**Docket 505
Haddam Quarter Solar, LLC
Johnson Lane, Durham, Connecticut
Development and Management Plan**

**Staff Report
August 11, 2023**

Site Plan

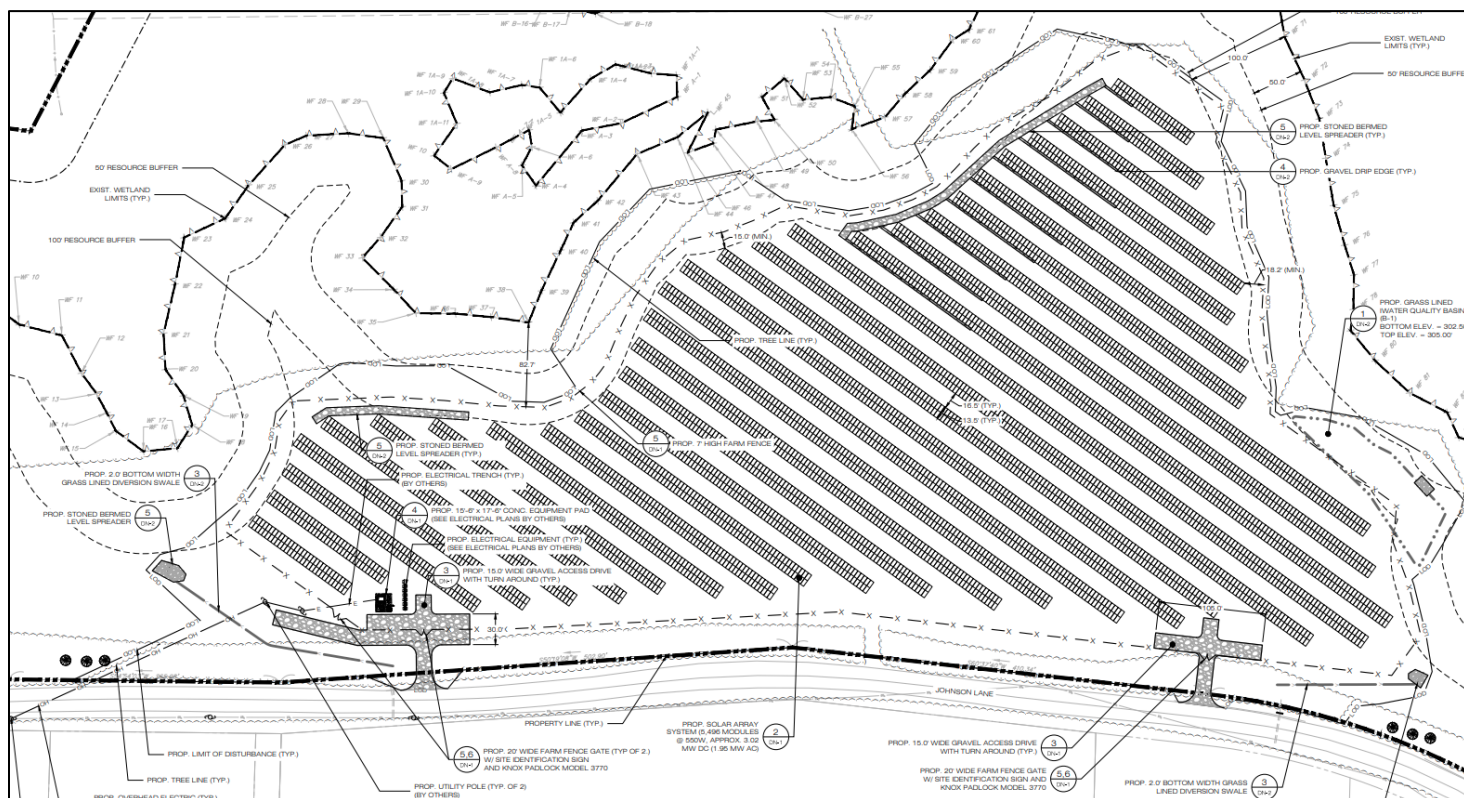
The final site plan includes the final facility layout, and specifications for the access drive, electrical interconnection, equipment pad, perimeter fence design and stormwater management control structures.

The reduced facility will consist of 5,496 VSUN550 solar panels rated at 550 Watts with an output of 1.95 MW AC. The output of the original facility was 2.8 MW AC (7,434 Trina solar panels rated at 465 Watts). The solar panels will be installed at a 25-degree angle on a fixed, post-mount racking system. A 16.5-foot vegetated aisle will be established between panel rows. The fenced area of solar array would occupy approximately 8.9 acres.

Access to the facility will be from two, 15-foot wide gravel access drives extending north from Johnson Lane; one on the east end and one on the west end of the site. The east access drive will extend for approximately 80 feet to facilitate post-construction maintenance activities. The west access drive will extend for approximately 150 feet, to the facility equipment pad. Site access would be controlled by two 20-foot wide swing gates.

A 15.5-foot by 17.5-foot concrete equipment pad will be installed along the west end of the solar array for a transformer, switchgear, switchboard and data acquisition system. From the equipment pad, two utility poles, owned by Eversource, would be installed adjacent to the west end of the access drive to support the meter and recloser.

One permanent stormwater management basin will be constructed at the southeast end of the site with an outflow directed to a downgradient wetland area. Grass-lined swales with riprap outflow structures will be established near both access drives. Gravel drip edge dissipaters will be installed where the solar panel rows are installed on a small knoll that has a grade of 20-25 percent. The dissipaters will direct flows to a gravel berm at the base of the knoll.
